## Spartan Fire, LLC

Campaign Service Bulletin  
CSB25-170-001

- DATE:** 5/22/2025
- APPLIES TO:** This service bulletin applies to certain model year 2024-2025 Gladiator model emergency response chassis cabs built between January 2024 and August 2024.
- CONDITION:** VIN data label and matching body installed label for 2024 X15 engines were not updated from 15W-40 to 10W-30 viscosity when the engine oil viscosity was changed in production.
- CORRECTION:** Replace VIN data label and matching body installed label with new label containing the correct viscosity.
- LABOR ALLOCATION:** 0.5 hour
- CLASSIFICATION:** E3

Figure 4.1

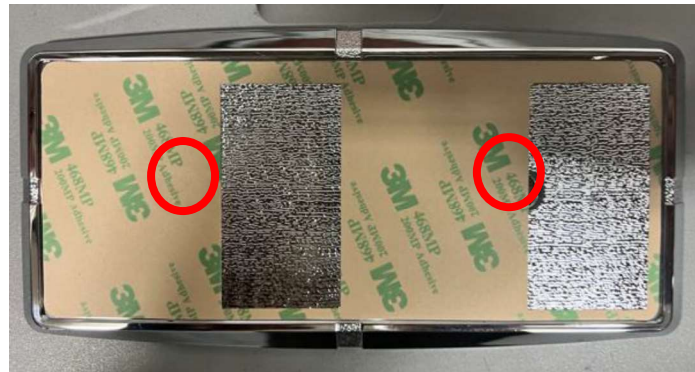
- b. Pull the old bezel off the truck and discard it.
  4. Install the new bezel onto the truck.
    - a. Locate holes in bezel and screw onto the truck. *See figure 4.1*
